# DART SERVICE INSTRUCTION

TO AMEND INSTALLATION INSTRUCTIONS IIN-D117-837 REV. B AND  
INSTRUCTIONS FOR CONTINUED AIRWORTHINESS ICA-D117-837 REV. 1  
REF. TCCA STC: SH13-22  
REF. FAA STC: SR03353NY

A	NEW ISSUE	RF	14.09.03
REV.	DESCRIPTION	BY	DATE
DESIGN	RF	<b>DART AEROSPACE LTD</b> HAWKESBURY, ONTARIO, CANADA	
DRAWN	RF		
CHECKED	HS	DRAWING NO.	REV. A
MFG. APPR.	N/A	DSI 9706	SHEET 1 OF 3
APPROVED		TITLE	SCALE
DE APPR.		BRACKET MODIFICATION	NTS
DATE	14.09.03	COPYRIGHT © 2014 BY DART AEROSPACE LTD THIS DOCUMENT IS PRIVATE AND CONFIDENTIAL AND IS SUPPLIED ON THE EXPRESS CONDITION THAT IT IS NOT TO BE USED FOR ANY PURPOSE OR COPIED OR COMMUNICATED TO ANY OTHER PERSON WITHOUT WRITTEN PERMISSION FROM DART AEROSPACE LTD.

**FIGURE 1. D4911-5 BRACKET INSTALLATION**  
(RH INSTALLATION SHOWN, LH OPPOSITE)

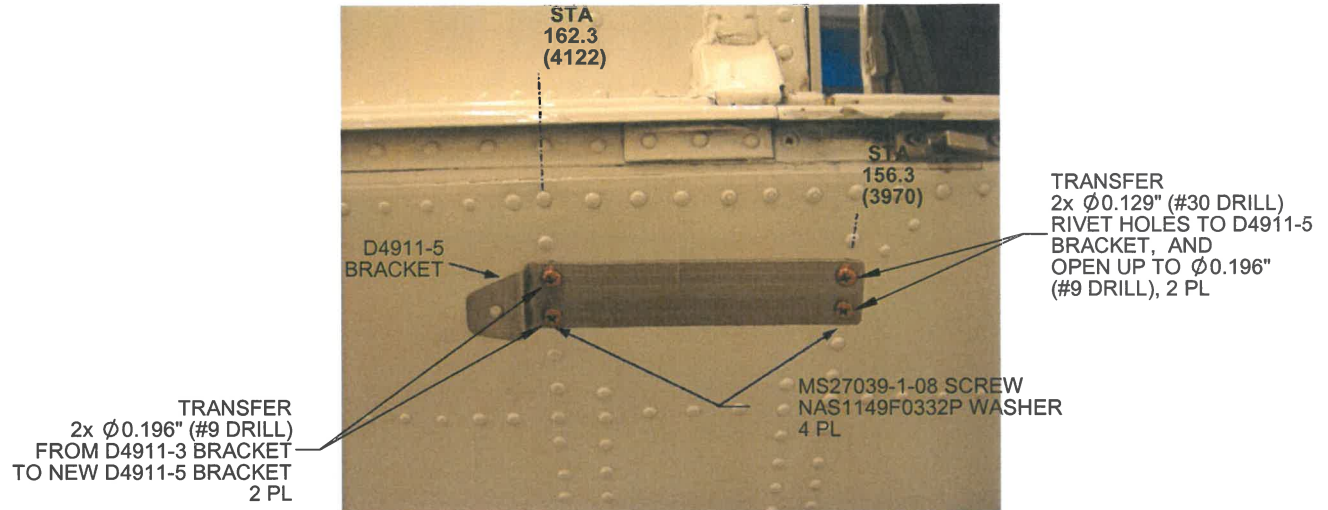
The purpose of this Dart Service Instruction (DSI) is to provide instructions to replace the D4911-3 Bracket with a D4911-5 Bracket for customers who already have D117-837-011 at CHG 002 or CHG 003. The D4911-5 Bracket will better distribute the drag load from the D117-837-011 Heli-Utility-Basket to the airframe in flight.

- 3.1 Temporarily remove LH/RH side cabin outboard floor panels as applicable.
- 3.2 Using D4911-3 Bracket as a template, transfer 2x  $\varnothing 0.196$ " (#9 drill) holes from D4911-3 to new D4911-5 Bracket as shown in Figure 1.

- 3.3 Using the D4911-5 as a template, remove two rivets at STA 156.3 (3970) under the D4911-5 Bracket. Transfer drill these rivet holes to the D4911-5 Bracket as shown in Figure 1. Enlarge rivet holes to  $\varnothing 0.196$ " (#9 drill) in the aircraft rib and on the D4911-5 Bracket. Transfer  $\varnothing 0.098$ " (#40 drill) for MS21069L3 anchor nut and c/sink/dimple holes for NAS1097AD3-(4) rivet as shown in Figure 2. Deburr and touch-up aircraft holes with Alodine 1200/1201 per MIL-C-5541.

- 3.4 Install 2x MS21069L3 anchor nuts using NAS1097AD3-(4) rivets as shown in Figure 2.
- 3.5 Install D4911-5 Bracket into the aircraft ribs using 4x MS27039-1-08 screws and 4x NAS1149F0332P washers as shown in Figure 1. Torque screws to 20-25 in-lbs (2.3-2.8 N-m).
